SERVICE BULLETIN

RELEASED: 4-11-07
REVISED:
(REV. 01)
BULLETIN: #1-07

1/2" Diaphragm Pumps MODELS AFFECTED: See list below.

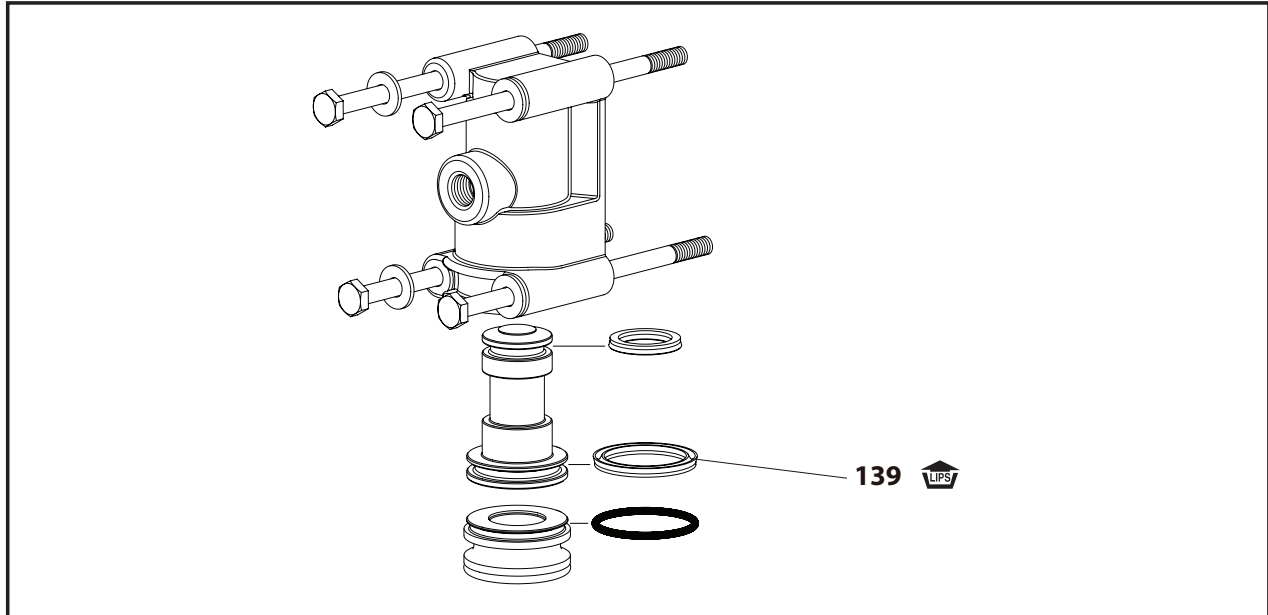
1. Item 139, 93116 "U" cup (nitrile) replaced by 96383 (polyurethane).
2. Change effects models and service kits built beginning April 23, 2007 (S/N D0237XXX or GD0237XXX).
